E/ECE/324 }
E/ECE/TRANS/505 } Rev.2/Add.109/Rev.1

Addendum 109: Regulation No. 110

Revision 1

**I. SPECIFIC COMPONENTS OF MOTOR VEHICLES USING COMPRESSED NATURAL GAS
(CNG) AND OR LIQUIFIED NATURAL GAS (LNG) IN THEIR PROPULSION SYSTEM;**

Fig. 1-2

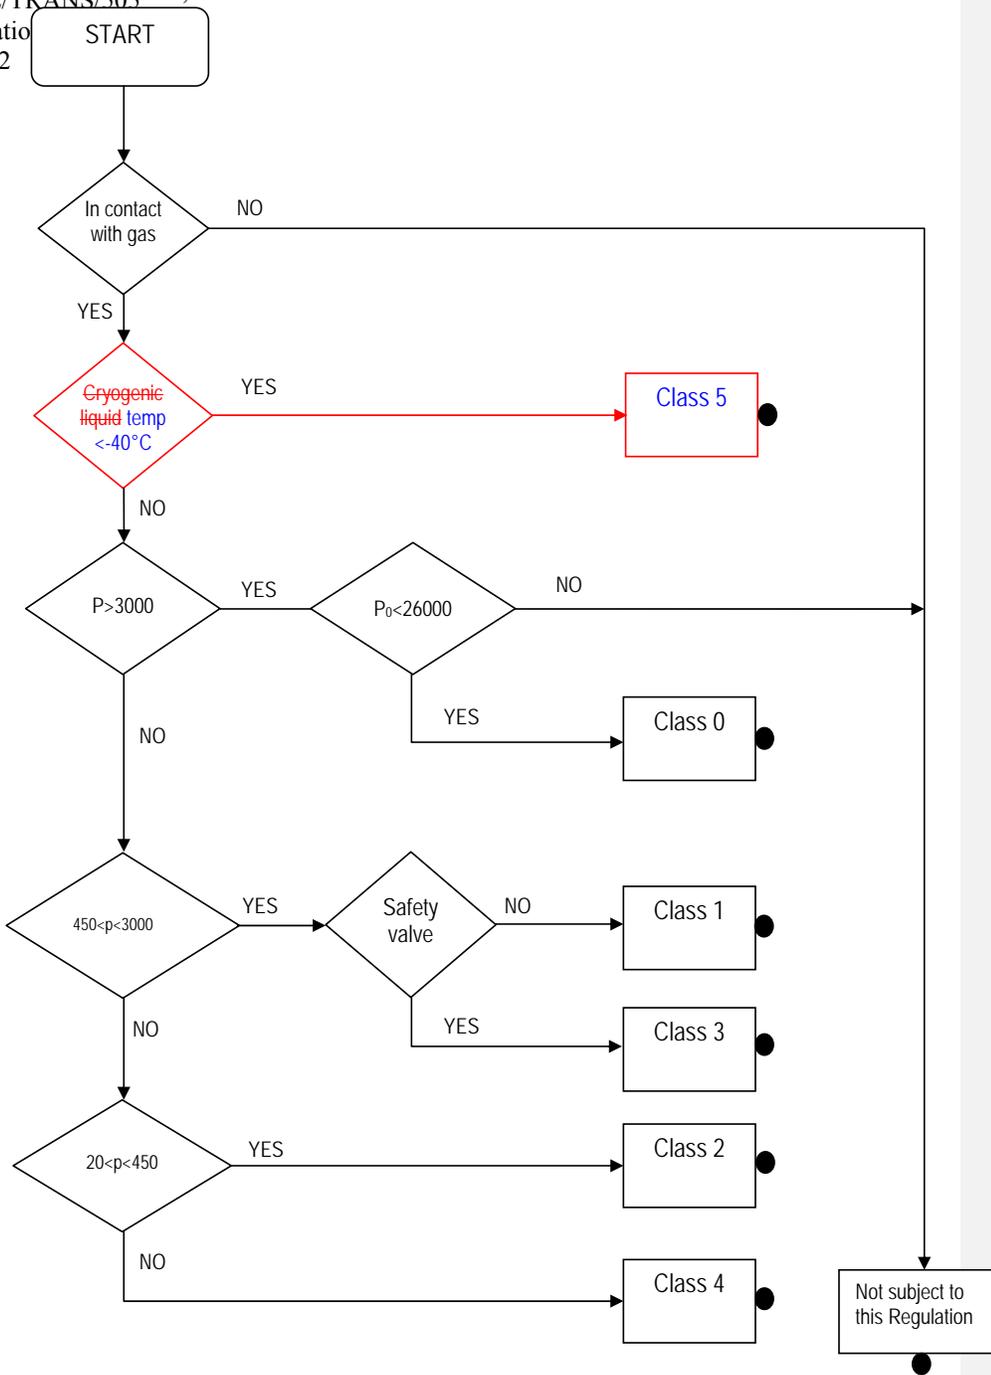
Comment [pc2]: Non return valve replaced by check valve. Same function other name.

PROVISIONS REGARDING LNG IDENTIFICATION MARK FOR PUBLIC SERVICE VEHICLES (M2 and M3)

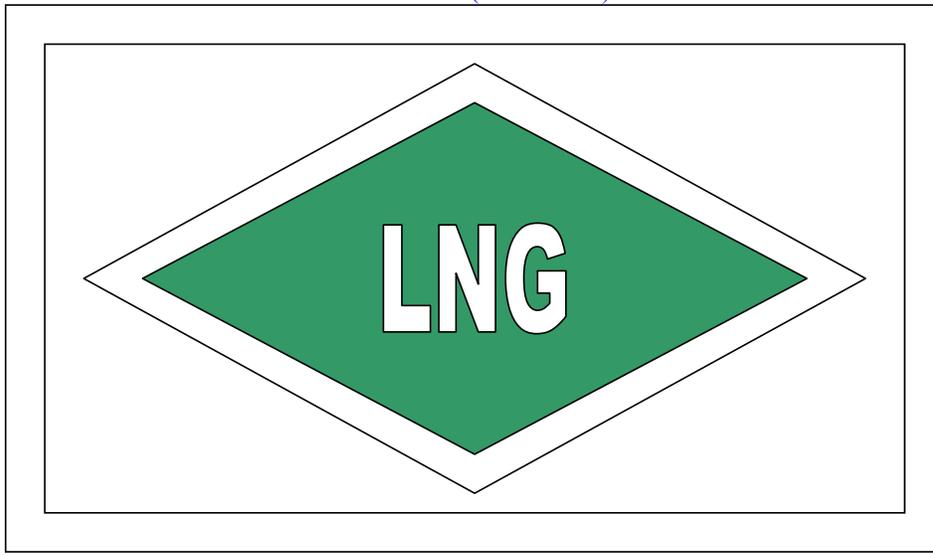
Comment [pc38]: The purpose of this label is to prevent the system for overfilling and not complying with the 5 day hold time.
